INSTRUCTIONAL BULLETIN NO. 17-09

Regarding Revised Standard Drawings

Effective February 9th, 2018 letting (November 29th, 2017 Turn-in), the following Standard Drawings have been revised. Also, Section 5, Index of Standard Drawings, of the Roadway Design Guidelines has been revised to incorporate these changes.

SURFACE MOUNTED FLEXIBLE DELINEATOR

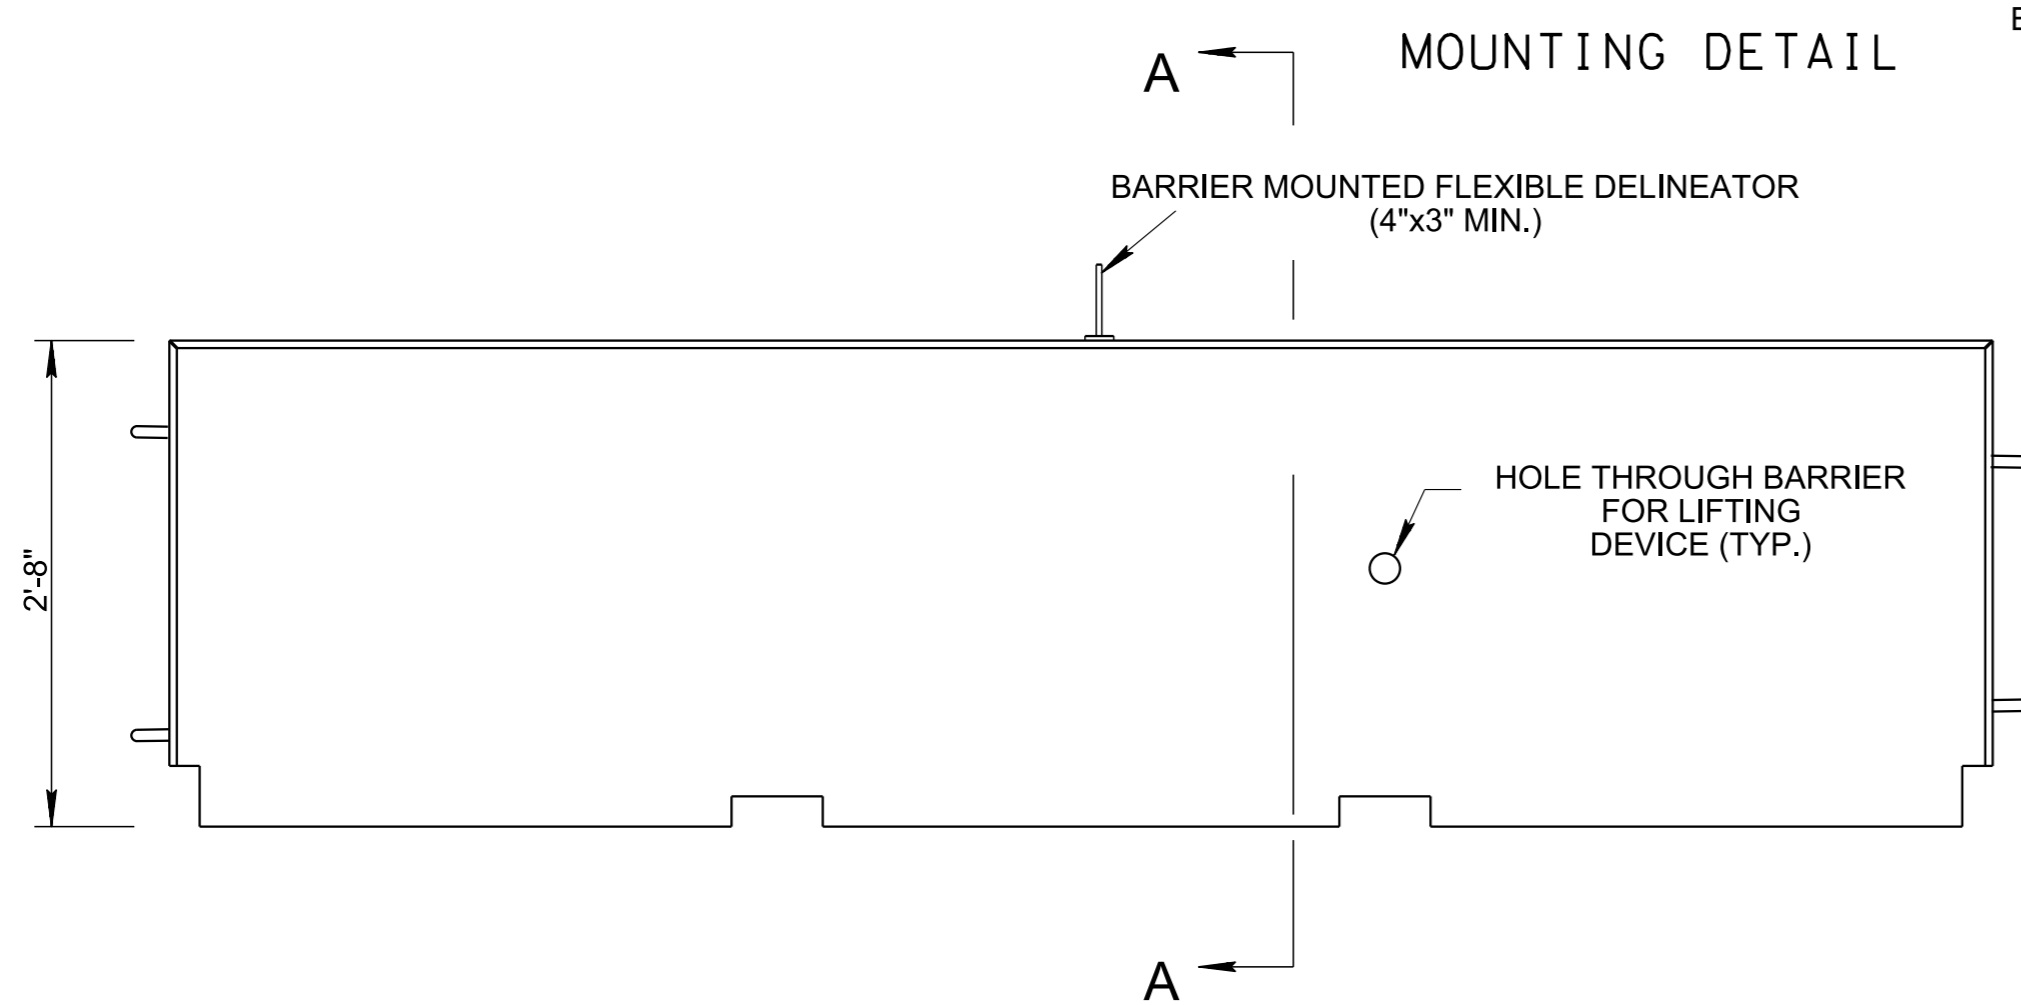
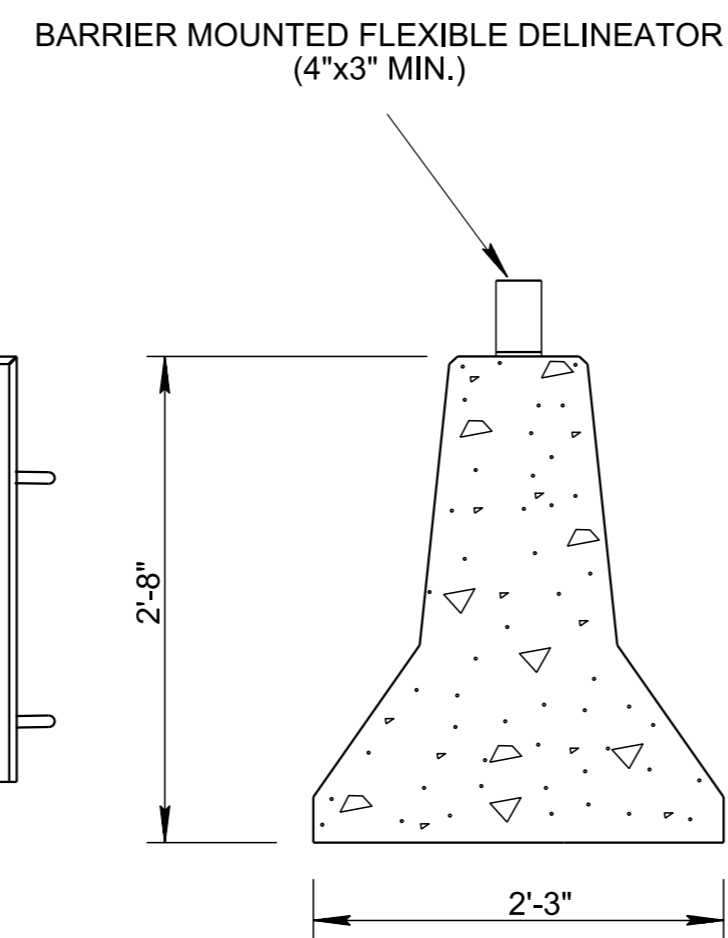
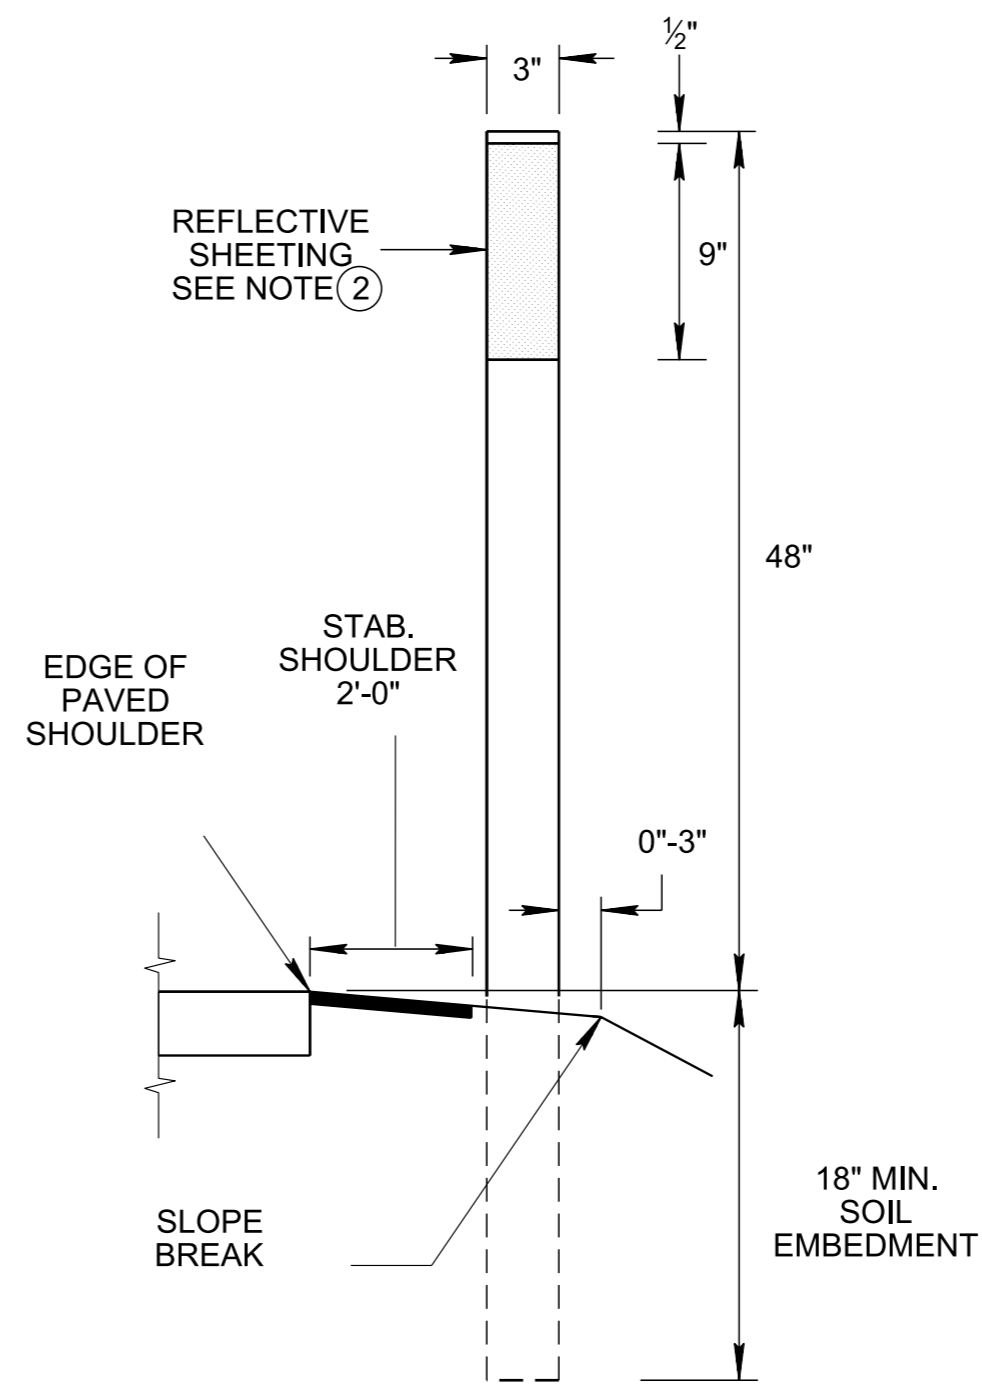
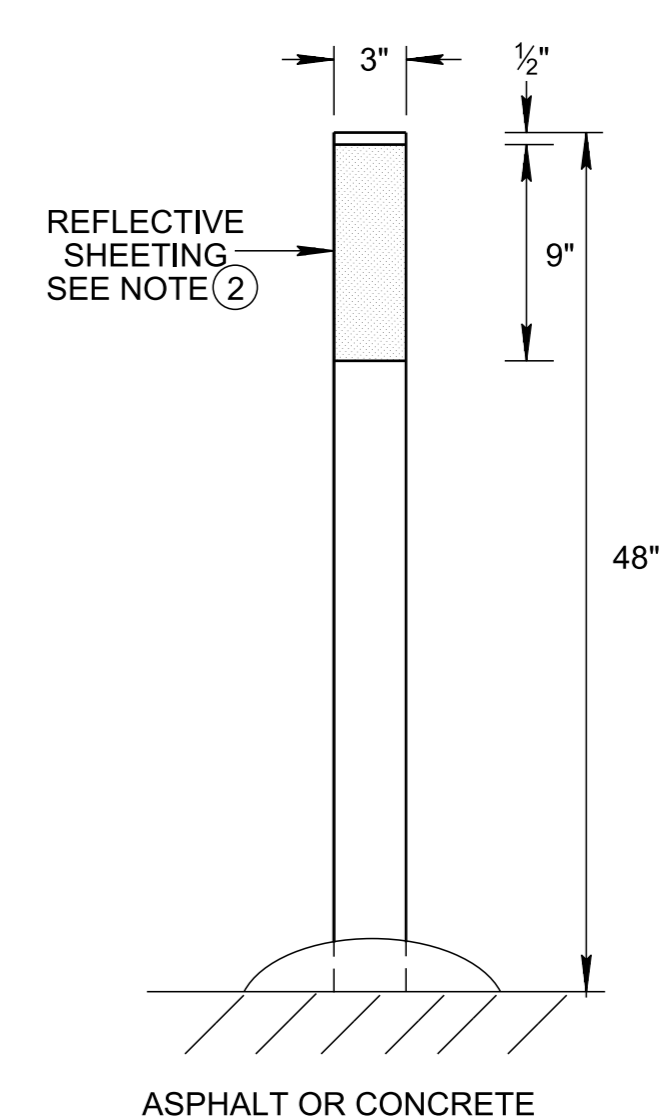
REV. 3-16-17: ADDED DETAIL FOR SURFACE MOUNTED FLEXIBLE DELINEATOR. ADDED GENERAL NOTES. MODIFIED THE NAME OF THE DRAWING. CHANGED THE PAY ITEM NUMBERS. REPLACED VERTICAL PANELS WITH BARRIER MOUNTED FLEXIBLE DELINEATORS.
